Springwell Solar Farm

Volume 8
A15 Road Safety Audit
& Designer Response

Springwell Solar Farms – A15 Access Works

Stage 1 Road Safety Audit

Gorse Hill Lane: Proposed tie-in to the existing arrangement is unclear

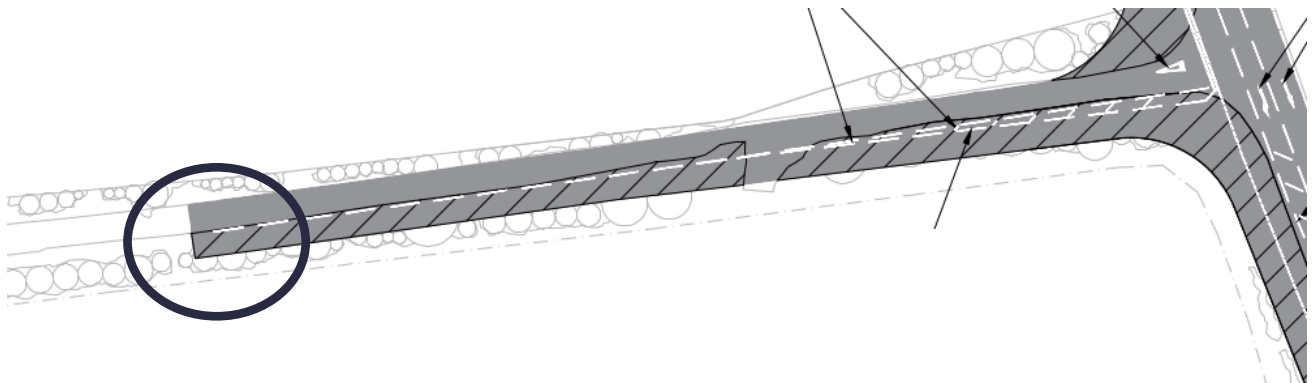
A1.1.1 Problem 1

Location: Gorse Hill Lane, tie-in to existing track.

Summary: Abrupt tie-in detail directs westbound traffic into verge, landscaping and trees, with potential for collision with landscaping/ trees and loss of control collisions.

Description: The proposed arrangement ties-in abruptly with the existing carriageway/ track width, with no taper or road markings to direct westbound traffic back into the existing track. Subsequently, westbound traffic is directed into the existing verge area, landscaping and trees with potential for collisions with these features and loss of control collisions, particularly during the hours of darkness when visibility is reduced.

Taper the proposed carriageway into the existing carriageway extents, providing a centre line where width allows.

RSA Issue	RSA Recommendation	Designer Response	Overseeing Organisation Response	Agreed Action
A1.1.1	Taper the proposed carriageway into the existing carriageway extents, providing a centre line where width allows.	<p>Agreed. A suitable taper will be provided to allow the road width to return to existing width.</p> <p>The design of this feature will be undertaken at the detailed design stage, secured under the CTMP and for the approval of LCC.</p>		
A2.2.2	Undertake assessment of existing carriageway conditions to determine suitability and resurface where applicable.	<p>Noted. It is proposed that the track leading from the A15 through to the proposed site access junction and beyond to the proposed taper will be in a metalled surface to adoptable standards.</p> <p>The design of the road makeup will be undertaken at the detailed design stage, secured under the CTMP and for the approval of LCC.</p>

Figure 2: Problem Location Plan

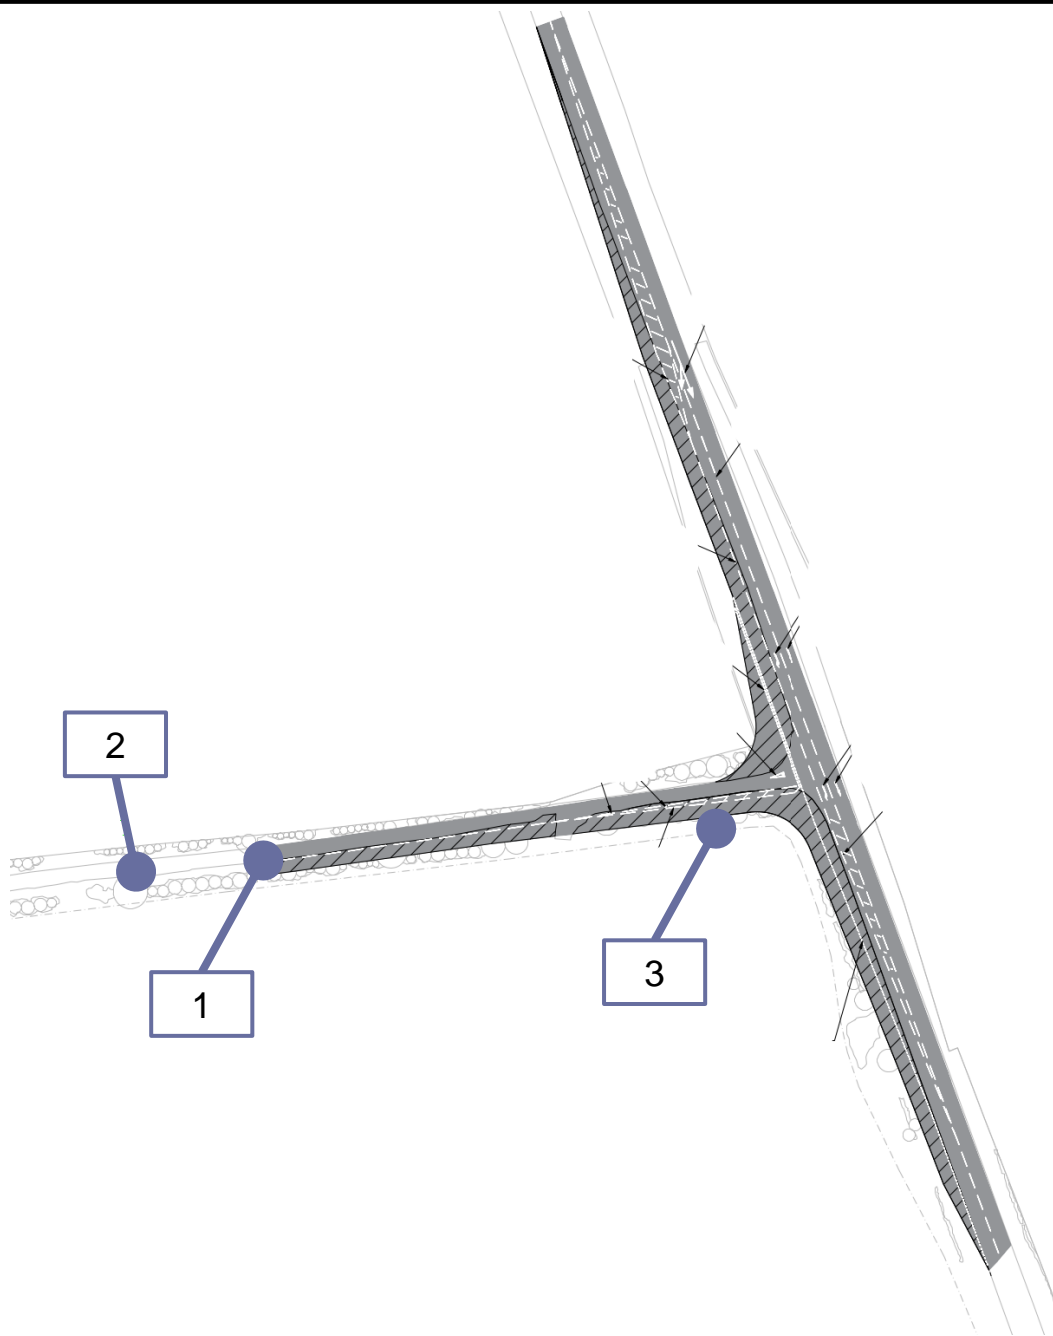
A2.2.2 Problem 2

Location: Gorse Hill Lane, existing interface.

Summary: Existing carriageway surface is worn and uneven, and appears unsuitable for heavy/ abnormal vehicles or increased traffic flows, which could result in loss of control collisions or potential for vehicles to shed their loads.

Description: The proposed development is predicted to provide an additional 405 vehicles utilising Gorse Hill Lane in both directions daily. The existing road surface is significantly uneven along its extents and additional vehicles, particular heavy goods and abnormal loads, using the route will result in further degradation to the carriageway surface. The unsuitable carriageway surface could lead to loss of control collisions, in addition to potential for vehicles to shed their loads.

Undertake assessment of existing carriageway conditions to determine suitability and resurface where applicable.

A2.2.1 Problem 3

Location: Gorse Hill Lane back of verges.

Summary: Levels difference between proposed carriageway extents and adjacent field could lead to carriageway failing to support the weight of larger vehicles, which could lead to loss of control collisions or vehicles shedding their loads.

Description: Gorse Hill lane is upgraded to provide one lane in each direction to accommodate the development traffic. There is an existing level difference between the carriageway and adjacent land. Large/ abnormal vehicles will add strain with potential for landslides resulting in loss of control collisions, vehicle toppling/ destabilisation and potential for vehicles to shed their loads.

Earthworks to be detailed to provide sufficient construction base for carriageway and expected vehicle loadings. Furthermore, where a levels difference is identified at the edge of the carriageway, the designer will need to undertake a Road Restraint Risk Assessment Process (RRRAP) to understand whether a VRS (vehicle restraint system) is required.

A2.2.1	Earthworks to be detailed to provide sufficient construction base for carriageway and expected vehicle loadings. Furthermore, where a level difference is identified at the edge of the carriageway, the designer will need to undertake a Road Restraint Risk Assessment Process (RRRAP) to understand whether a	<p>Noted. The earthworks design and an RRRAP assessment will be prepared at the detailed design stage, secured under the CTMP and for the approval of LCC.</p>

Figure 3: Problem Location Plan

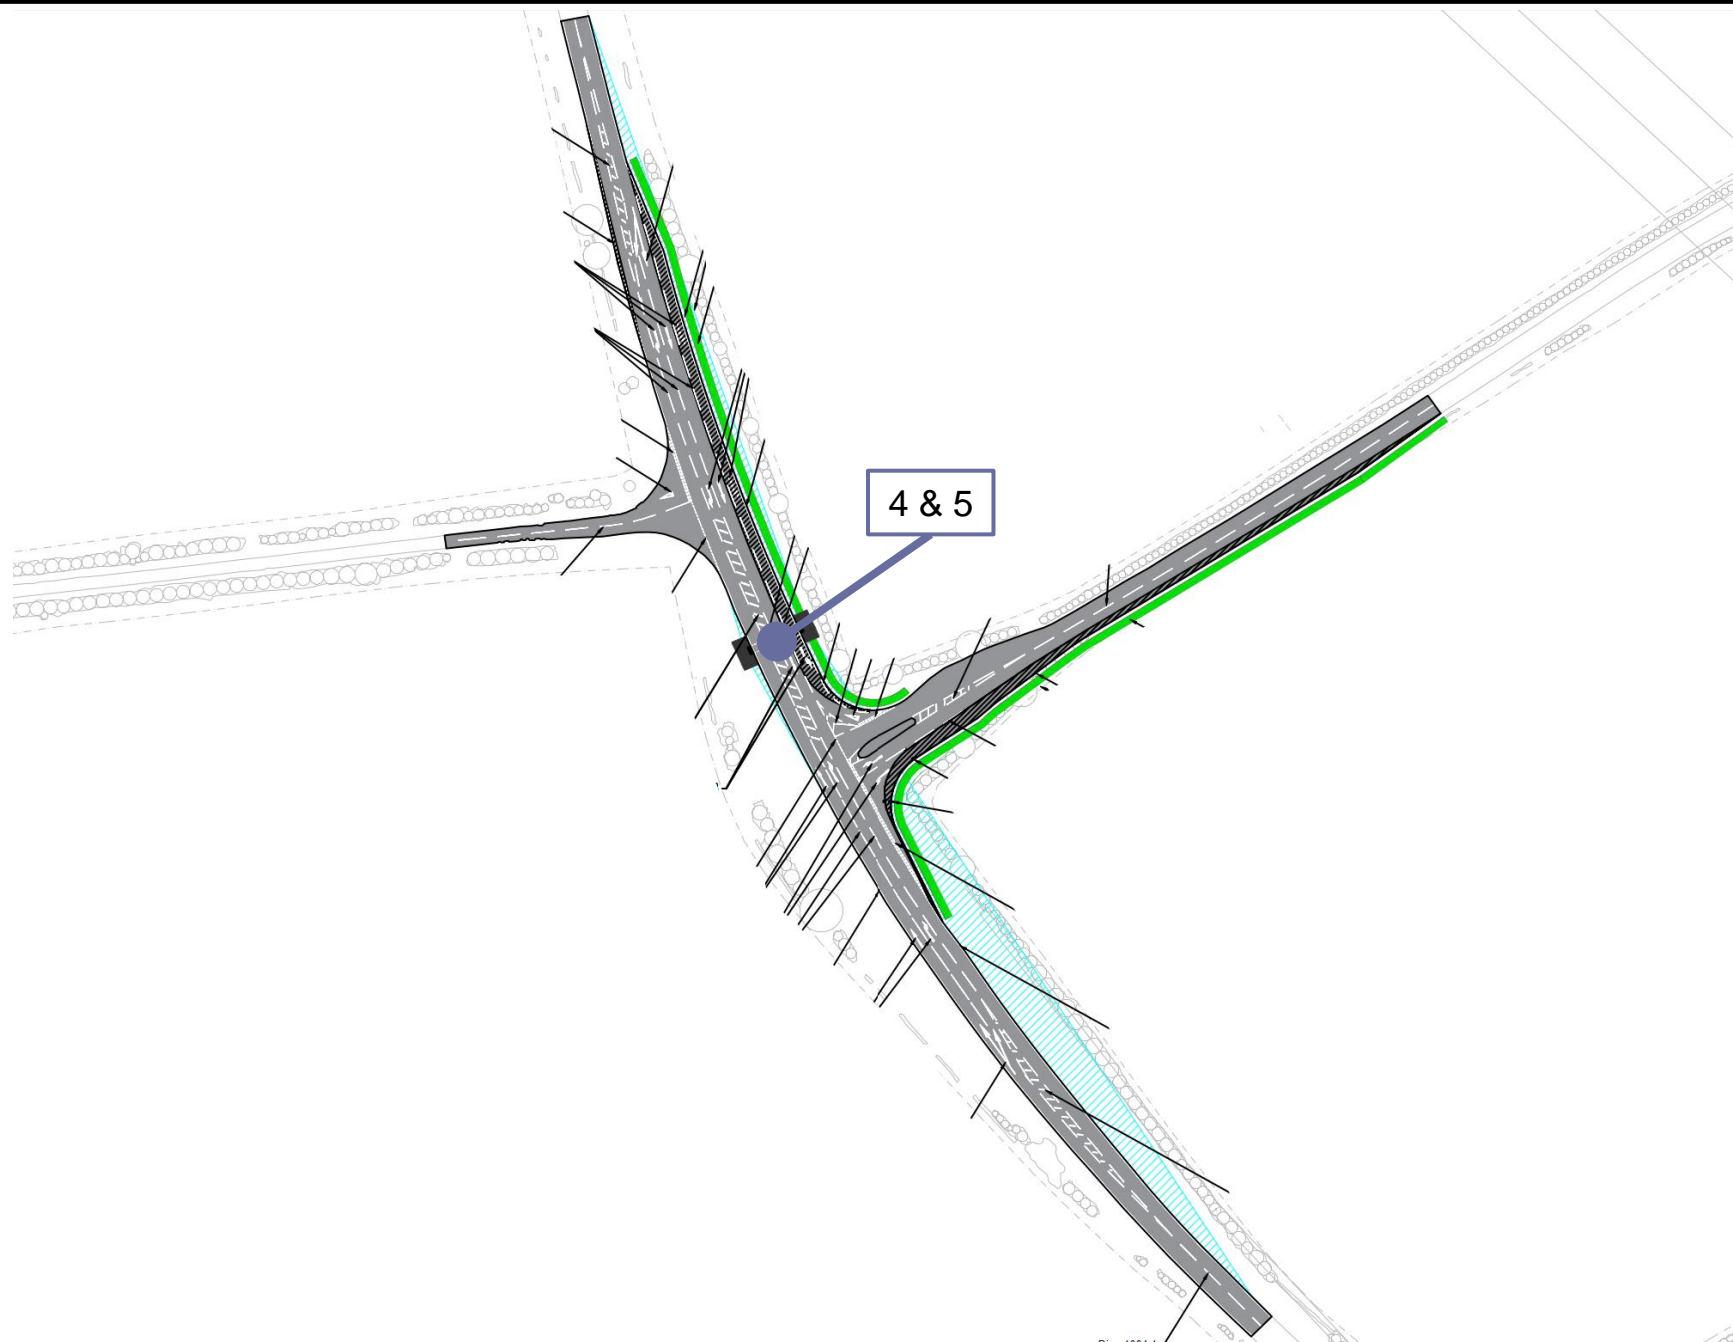
A4.1.1 Problem 4

Location: A15, proposed uncontrolled crossing c.40 metres north of B1191.

Summary: Proposed uncontrolled crossing may encourage pedestrian movements within carriageway at location with no footway connections, with potential for conflict and collision with vehicular traffic.

Description: An uncontrolled pedestrian crossing with refuge is proposed on the A15, to the north of B1191. The proposed crossing location does not correspond with any existing pedestrian infrastructure or Public Rights of Way. Provision of the crossing could encourage pedestrians to walk within the carriageway in conflict with vehicular traffic, with potential for collisions between these users.

Remove the pedestrian refuge from the scheme. Should the refuge be provided to deter overtaking on the A15, a splitter island may be provided as an alternative.

A5.1.1 Problem 5

Location: A15, proposed uncontrolled crossing c.40 metres north of B1191.

Summary: The absence of street lighting at the proposed uncontrolled pedestrian crossing may result in poor visibility of pedestrians, in particular during the hours of darkness, increasing the risk of collisions between vehicles and pedestrians.

Description: A new uncontrolled pedestrian crossing has been introduced to facilitate pedestrian movement across the carriageway. However, there is no existing or proposed street lighting in the vicinity of the crossing. During hours of darkness, drivers may fail to observe pedestrians. The lack of visibility may result in collisions between vehicles and pedestrians, or sudden braking for vehicles resulting in rear shunts.

Should pedestrian crossing be required, provide an illuminated beacon within the refuge. However, the Audit Team do question the purpose of the refuge and have recommended its removal.

VRS (vehicle restraint system) is required.			
A4.1.1	Remove the pedestrian refuge from the scheme. Should the refuge be provided to deter overtaking on the A15, a splitter island may be provided as an alternative.	A new Public Right of Way (PRoW) is proposed to cross the A15 at this location (EN010149-000149-2.4 Streets, Rights of Way and Access Plans.pdf). It is proposed that the island is retained.		
A5.1.1	Should pedestrian crossing be required, provide an illuminated beacon within the refuge. However, the Audit Team do question the purpose of the refuge and have recommended its removal.	A new Public Right of Way (PRoW) is proposed to cross the A15 at this location (EN010149-000149-2.4 Streets, Rights of Way and Access Plans.pdf). It is proposed that the island is retained. An illuminated bollard will be provided. The design of this feature will be undertaken at the detailed design stage, secured under the CTMP and for the approval of LCC.
